PRODUCT BULLETIN: 0004

BREATHTRACKER SOFTWARE UPDATE

PRODUCT CHANGE NOTIFICATION:

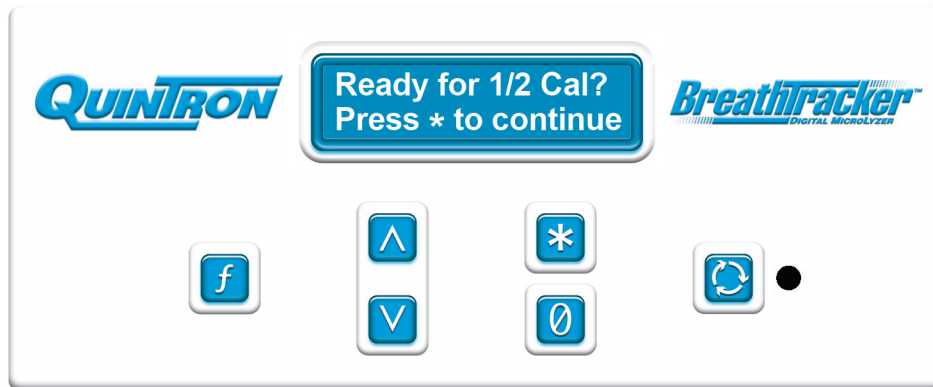
End-users are now being required to perform the half calibration procedure as a mandatory step during calibration. Many users are bypassing this procedure or not performing it correctly. This software update addresses this issue by not allowing the technician or end-user to bypass the half calibration procedure as well as other internal software fixes.

Below is the new display that will be seen.

Users must perform this procedure to ensure proper analysis of patient samples.

If you do not see the exact “Ready for 1/2 Cal?” display above during your calibration procedure, contact QuinTron to verify your software version at (800)542-4448 or (414)645-4222.
